CHANGE ORDER

Project Title: **EASTERN CORRIDOR UTILITIES**

Order No. 2
CGRS PR No. 2

PLC & Cellular Modem for Monitoring Panel

SHEET NO.
E5.0

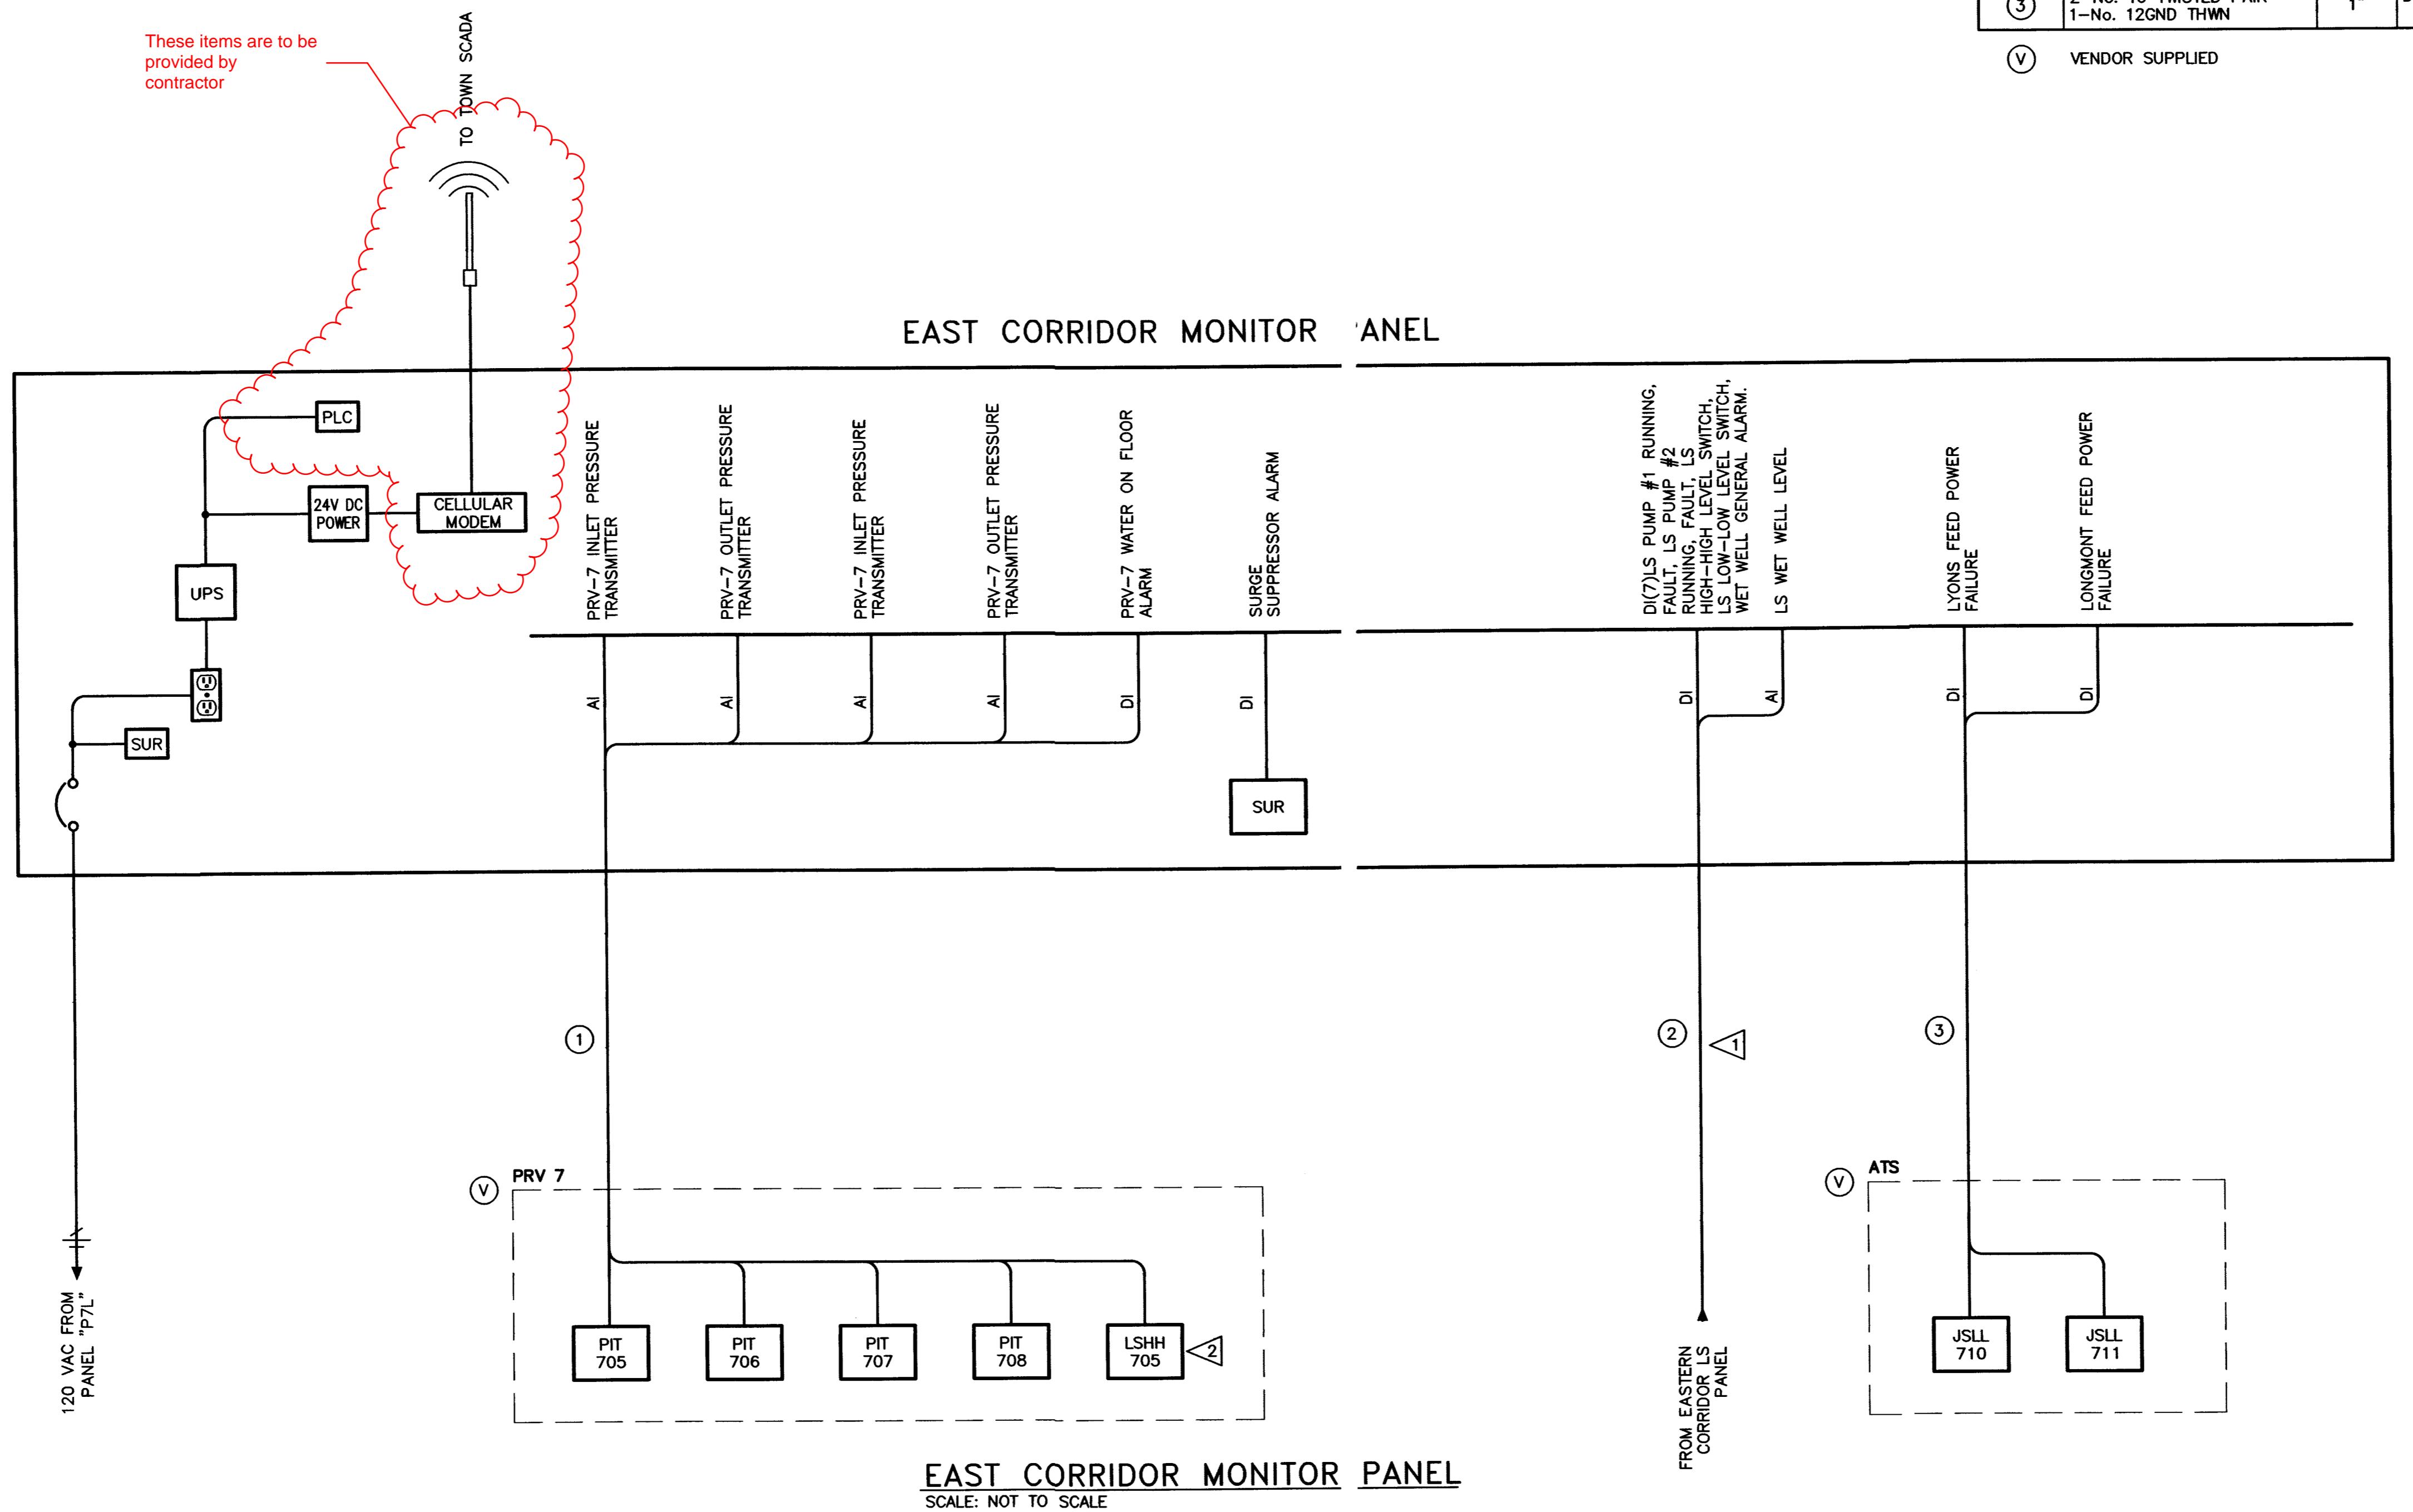
The proposal is to request the revision of one bid item to the Contract. The contractor's bid and Section 01025 – Measurement and Payment are attached for reference. Acceptance of this proposal will result in the revision of line item 55, "East Corridor Monitor Panel" to include an additional PLC and a Red Lion Cellular Modem, Model # SN/RAM-6901, both at a unit price to be determined per occurrence, to be used for 1 occurrence. Please provide a new lump sum payment for the revised line item 55 with the additions.

Please find the one attached document for reference: "2686 – Sheet E5.0" and "Section 01025 – Measurement and Payment"

Date Submitted:	7/31/2019
Project Name/Number:	Town of Lyons Eastern Corridor Utilities (JVA #2686c)
Change Order Number:	COP#187-001
General Contractor:	CGRS Inc.
Description of Change:	Supply PLC & Cellular Modem for Monitor Panel Per JVA Proposal Request -02 Dated 7/12/19

- 1 SAME CONDUIT AND CONDUCTORS AS EAST CORRIDOR LIFT STATION CONTROL PANEL.
- 2 IF DEVICE IS 24VDC, SAME CONDUIT MAYBE USED. OTHERWISE SEPARATE CONDUIT REQUIRED

(iii) PRESSURE REDUCING VALVE VAULT SECTION A
1/2" = 1'-0" —

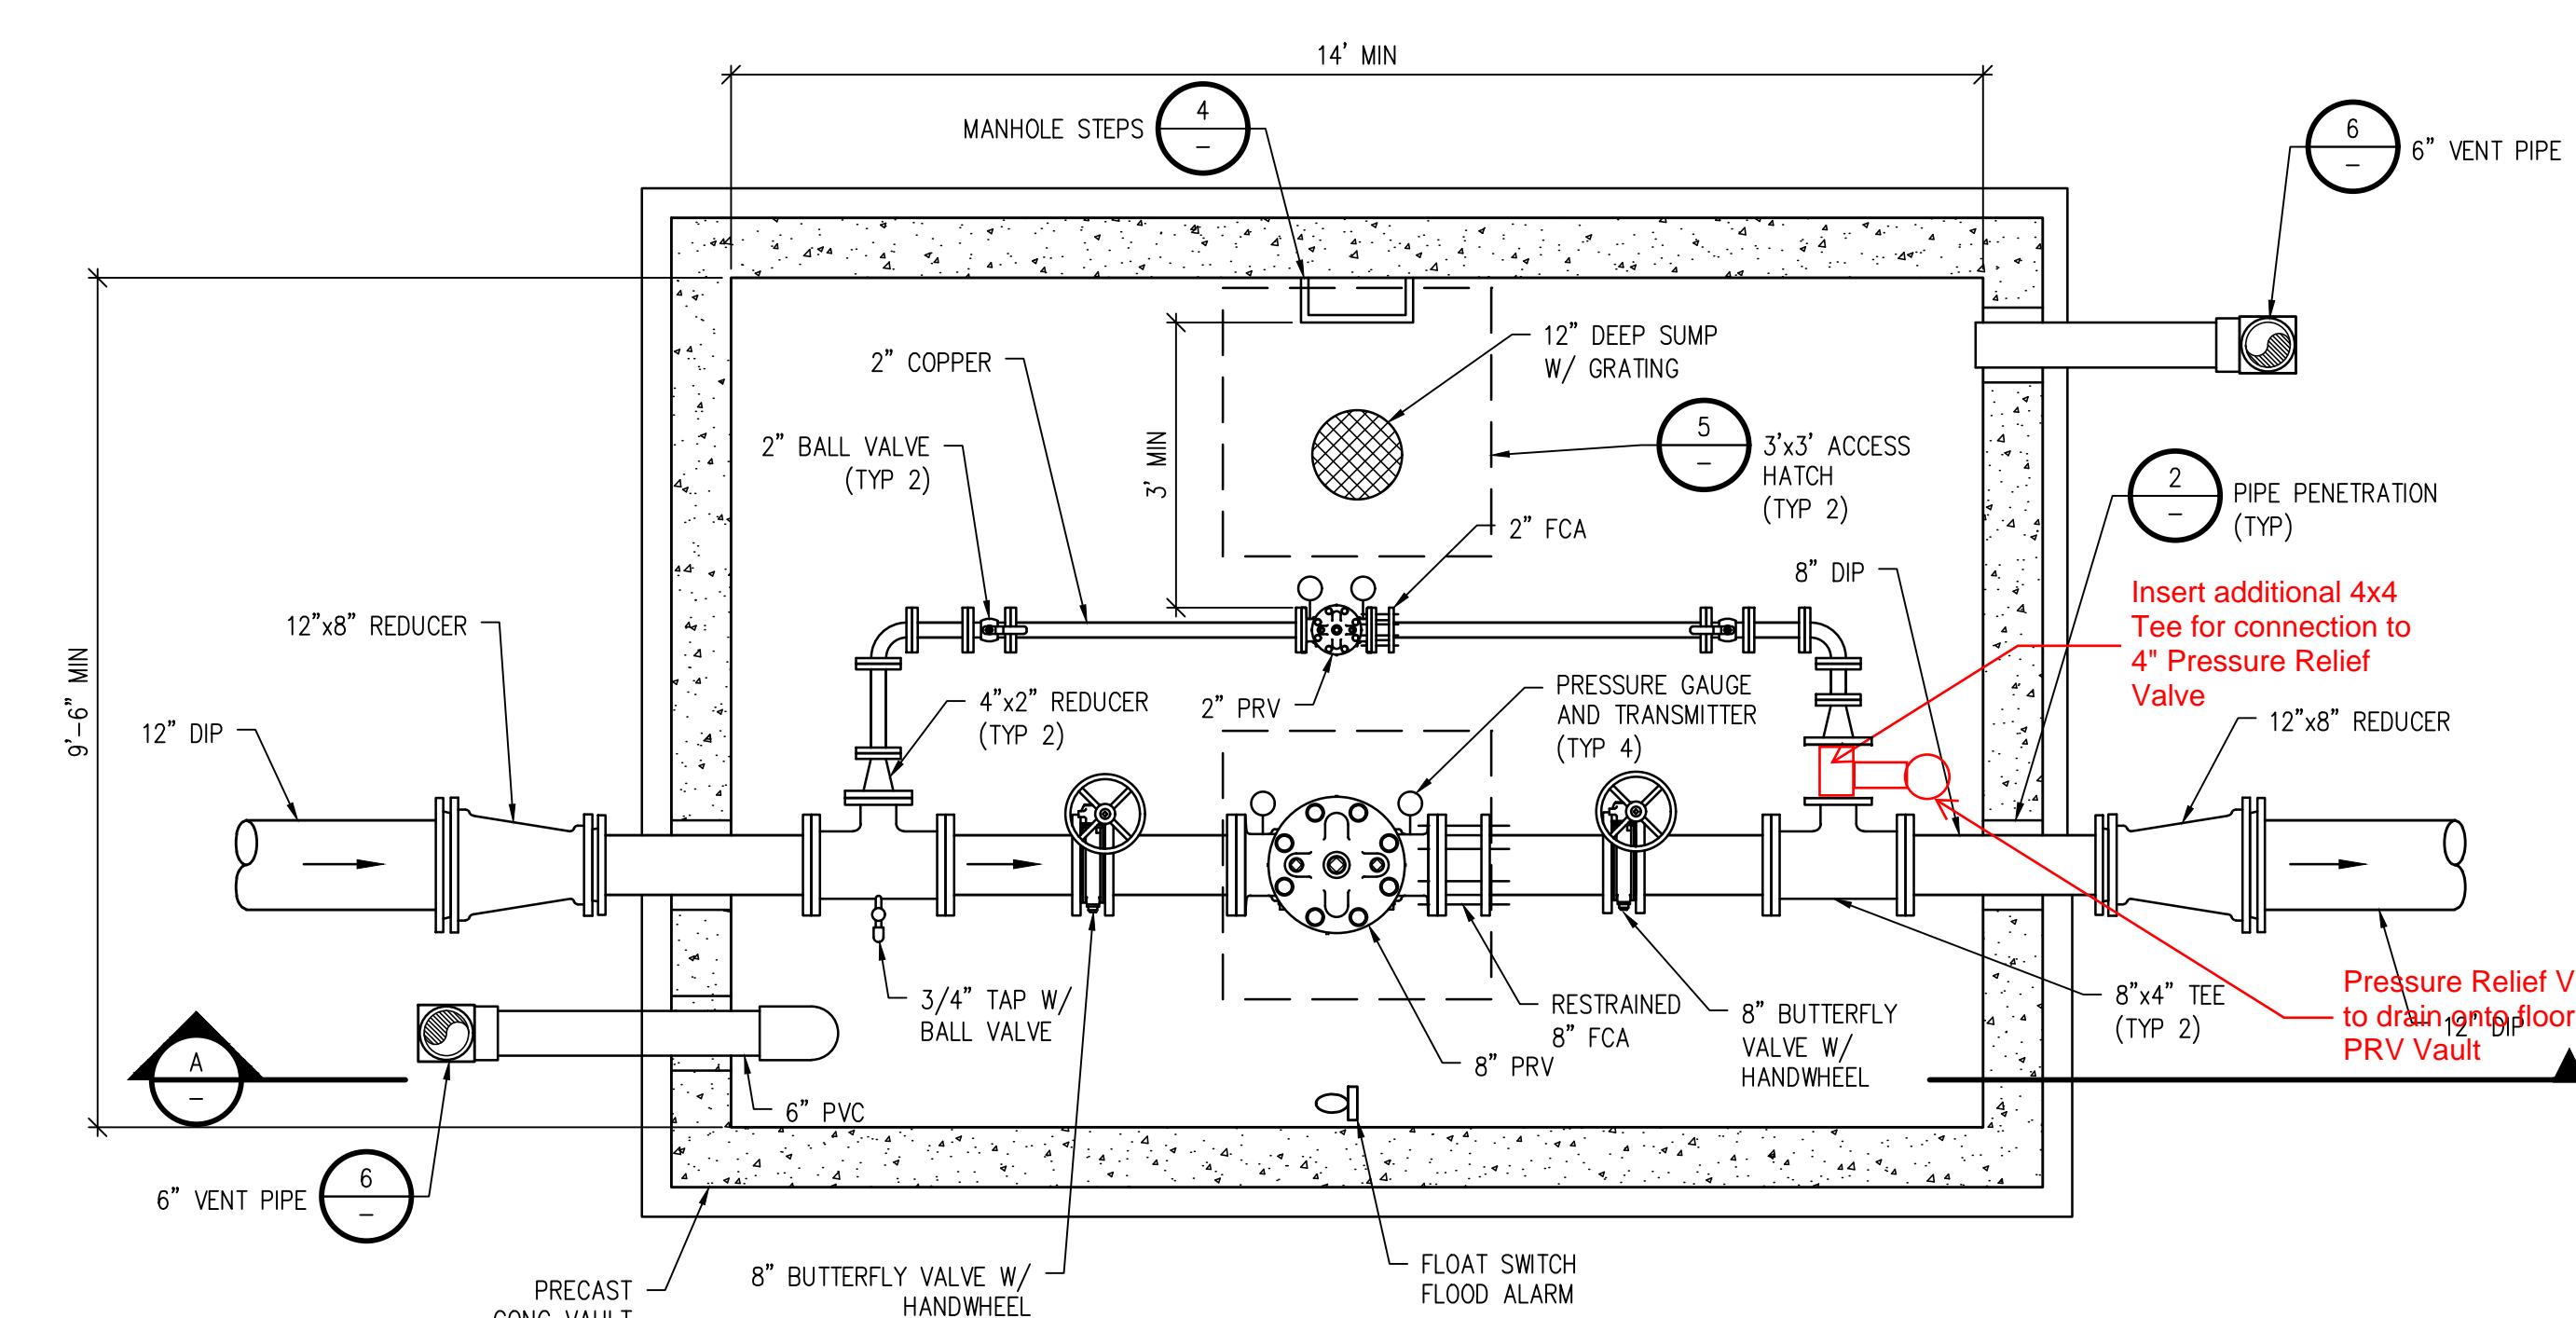
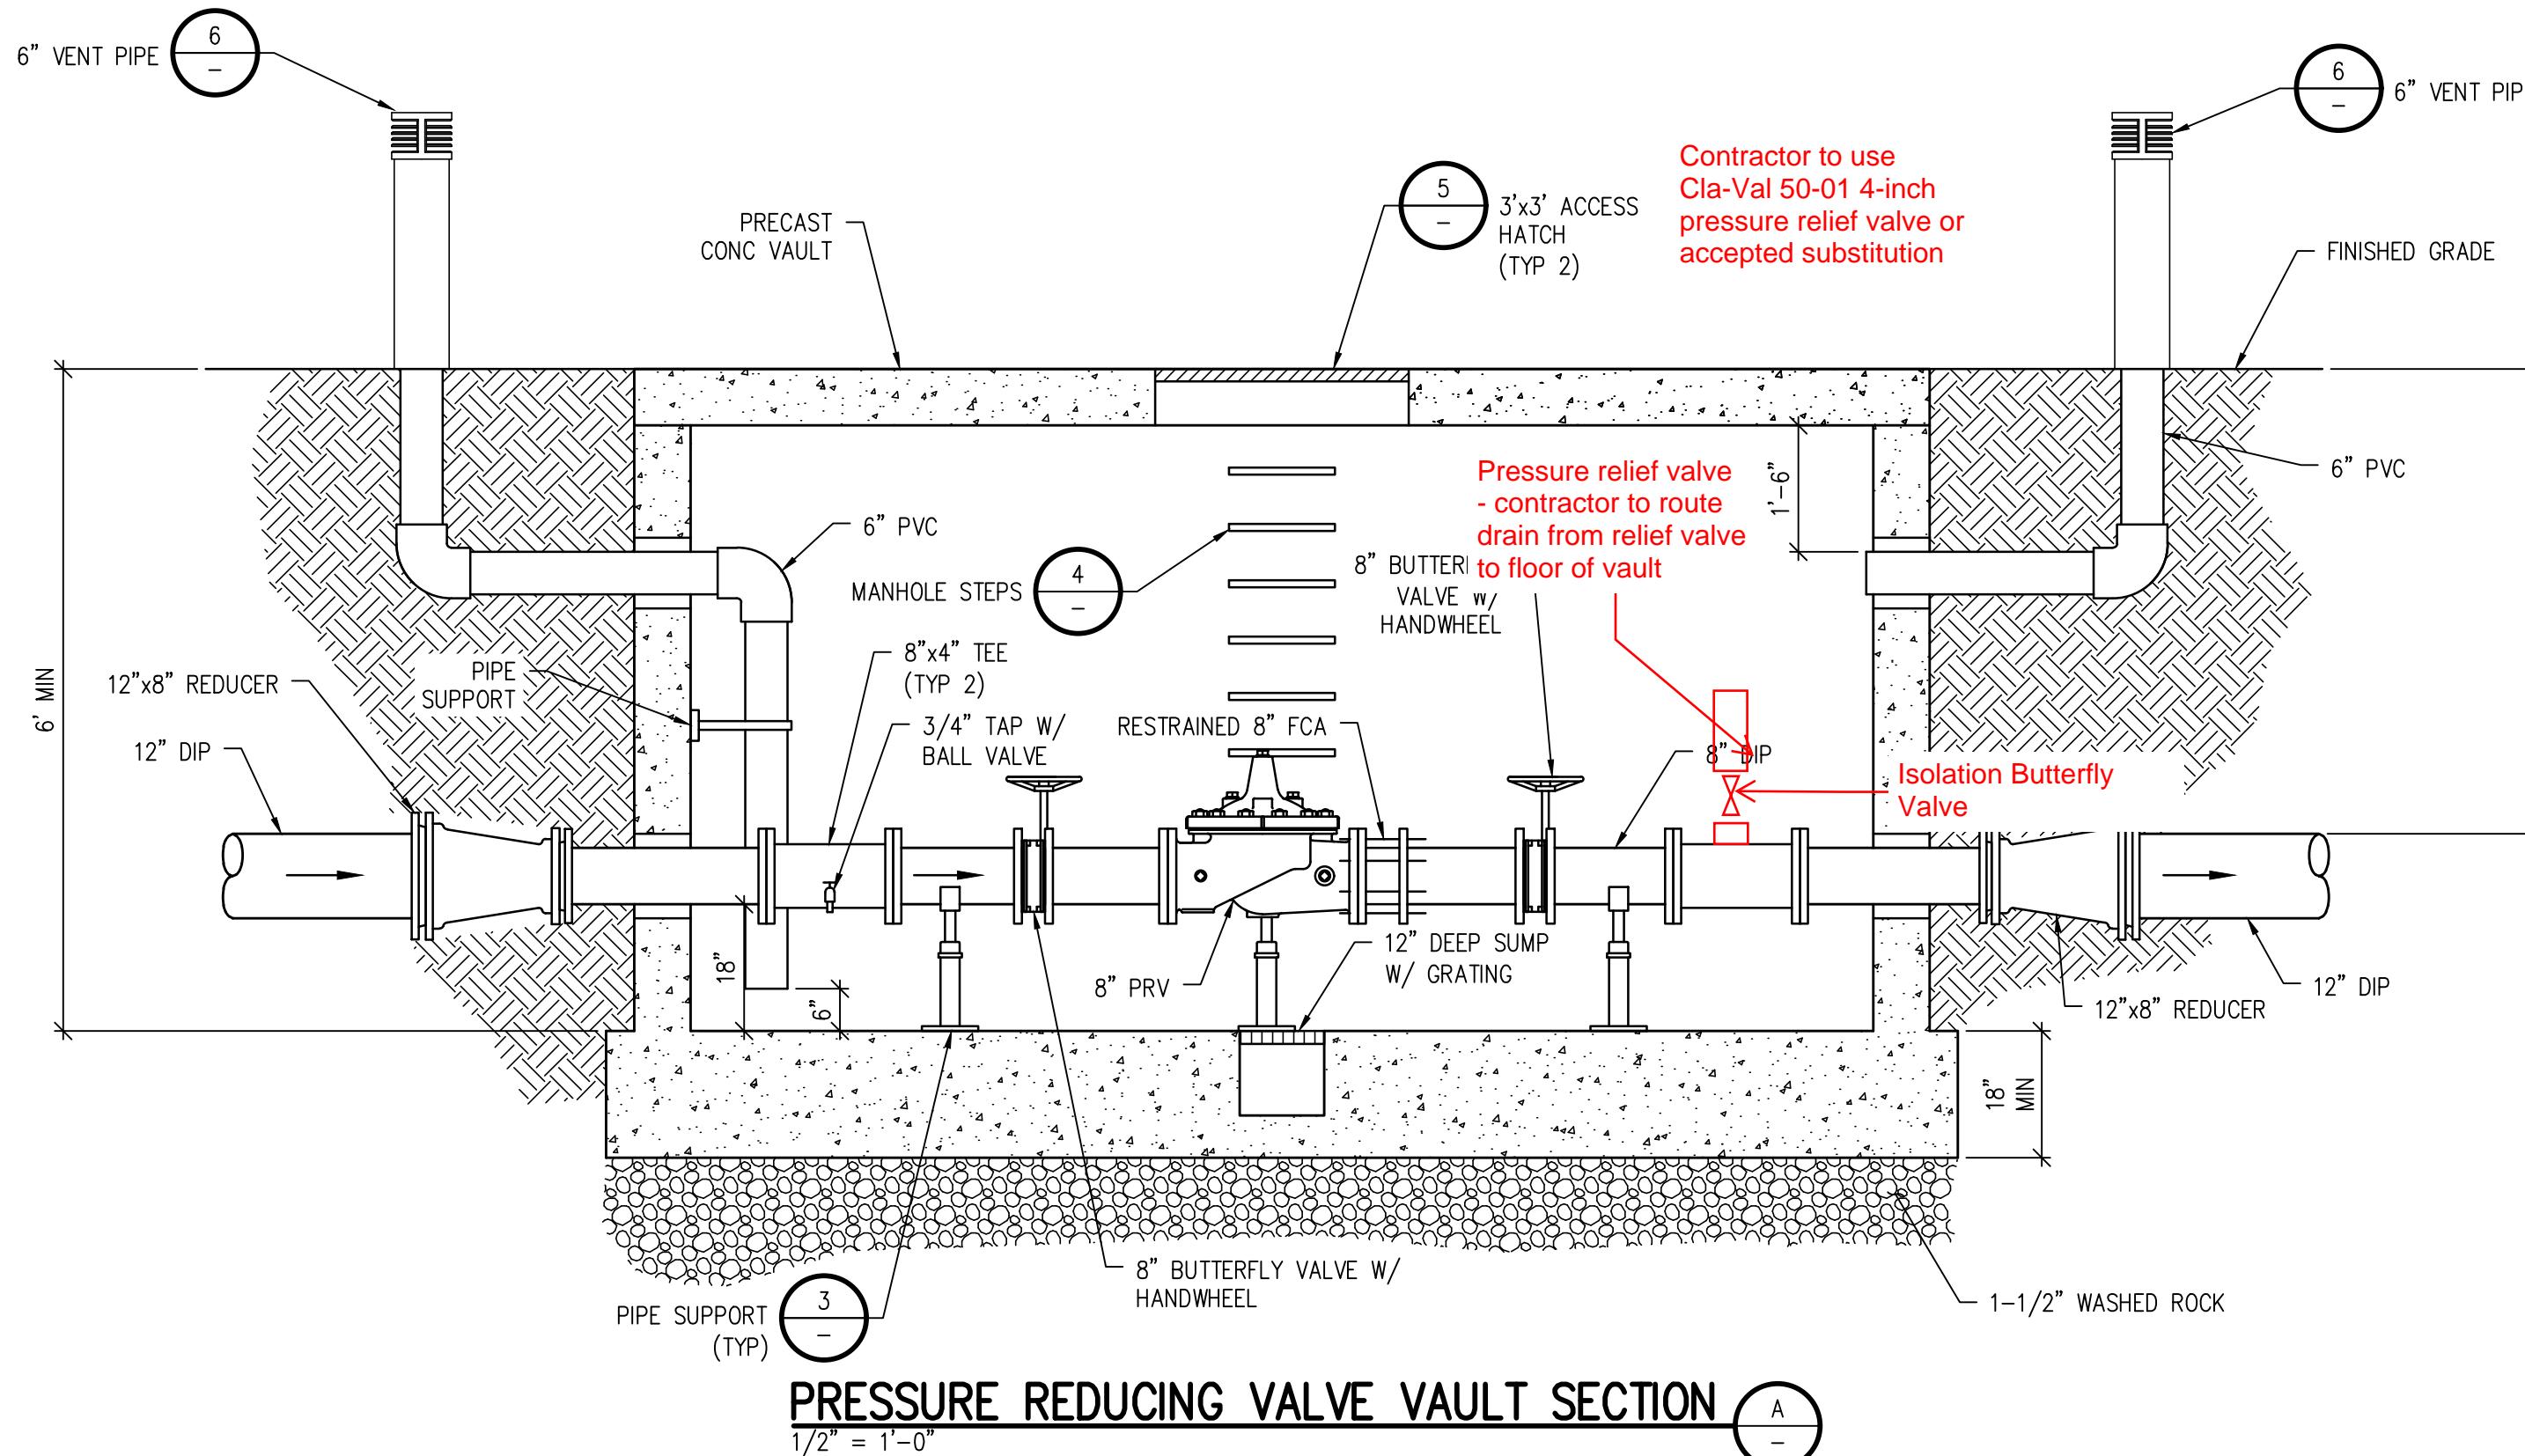
JVA has reviewed this PR and finds it necessary to add a Pressure Relief Valve to PRV #7. The costs for this PR are reasonable and comparable based on historical costs for this type of material and labor.

The proposal is to request the addition of one bid item to the Contract. The contractor's bid and Section 01025 – measurement and Payment have been revised to reflect changes described in this proposal request and are attached for reference. Acceptance of this proposal will result in the addition of line item 62, "4-INCH PRESSURE RELIEF VALVE AND ASSOCIATED APPURTENANCES" at a unit price to be determined per occurrence, to be used for 1 occurrence. Please find the three attached documents for reference: "2686c – Pressure Relief Valve Detail", "CGRS Eastern Corridor Utilities – BID (Revised)", and "Section 01025 – Measurement and Payment (Revised)".
